MIL-A-58066A(GL)
AMENDMENT-3

11 March 1971
SUPERSEDING
Amendment-2
30 September 1970

ALTIMETER, PRESSURE, PARACHUTIST'S

This amendment forms a part of Military Specification MIL-A-58066A(GL), dated 21 September 1966.

FIGURE 1
ALTIMETER, PRESSURE, ANNUNCIATOR 3

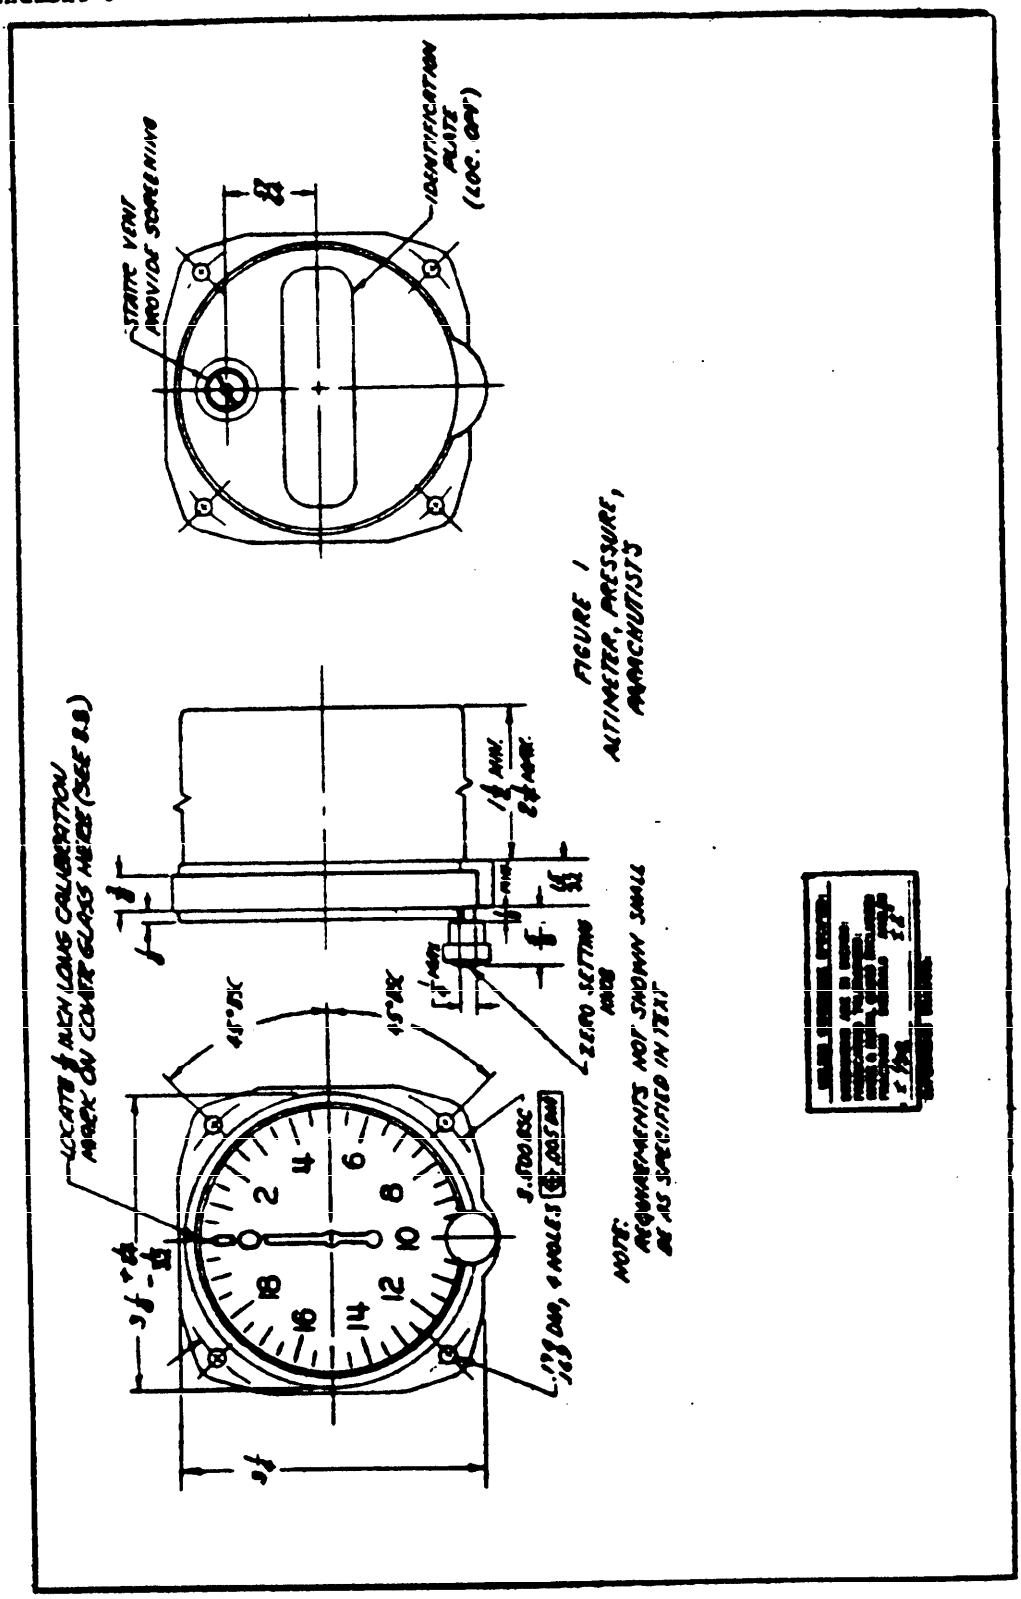
Figure 1.- Delete existing figure and substitute new figure 1 attached.
